## Technical and Procedural Newsletter

May 31, 2018

### **IN THIS EDITION: *Residential Driveway Standards***

Loudoun County Facilities Standards Manual, Chapter 4, Figure 6.

FIGURE 6

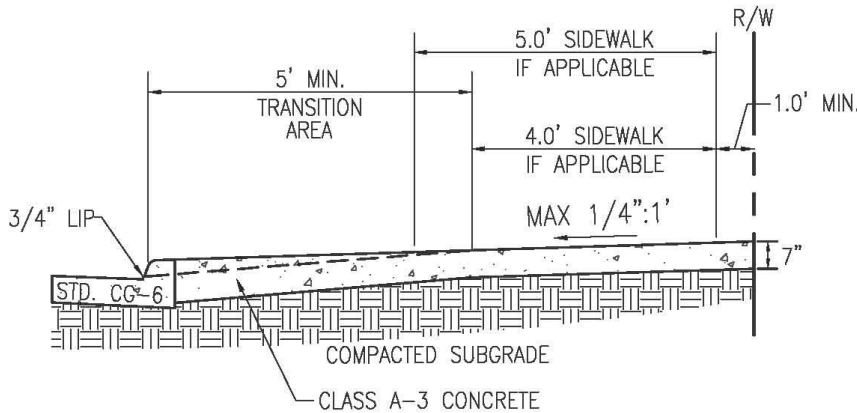
Specifically, the Loudoun driveway entrance standard (reproduced as uncorrected first figure below) does not show the six inch (6") aggregate under the concrete needed in order to be compliant with the VDOT standard (reproduced as the second figure below).

A future amendment to the FSM shall correct this figure to meet the VDOT standard. However, in the interim period, all new projects must reflect driveway aprons proposed as connecting to state maintained roadways as providing this six inch aggregate layer.
